**Re: Storm Water Inspection at Timberline Office Campus/ Franklin County.  
Permit #: 4GC04170\*AG**

This letter is written in follow up to a construction storm water inspection by Jerome Hoke and Paul Hafner, of the Ohio EPA, at Timberline Office Campus located at 4595, 4605, and 4611 Trueman Boulevard on July 16, 2013. The purpose of the inspection was to evaluate compliance with Ohio EPA's General Storm Water Permit Associated with Construction Activities. During the inspection, we noted the following:

**Figure 1: Silt fencing absent on eastern side of site.**

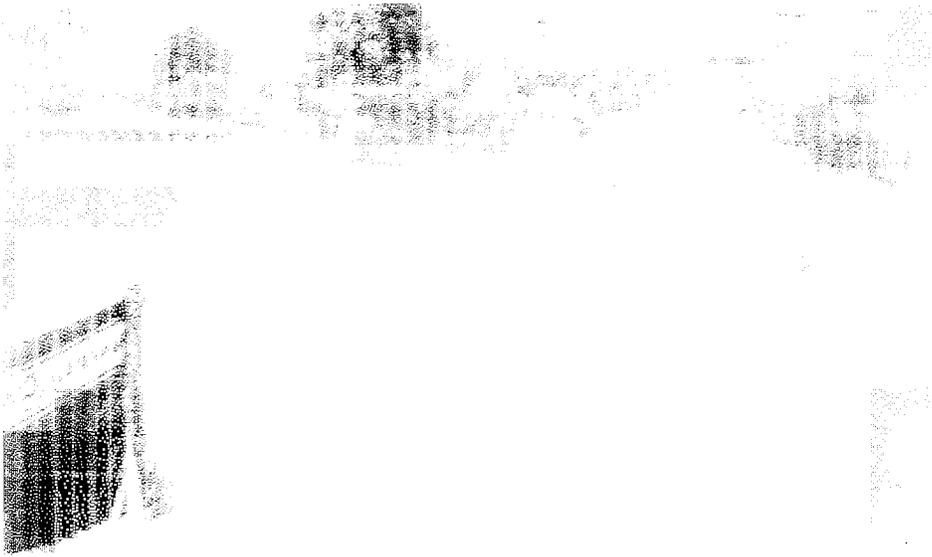
- Silt fence is absent on the eastern portion of the site and will require installation within three (3) days from receipt of this letter (See Figure 1).
- There appear to be two sediment basins on the southeast corner of the site (See Figure 2). The General Permit requires modifications to address sediment control. Please ensure a riser/skimmer is set to an elevation to accommodate the required storage of 67 cubic yards per acre of drainage
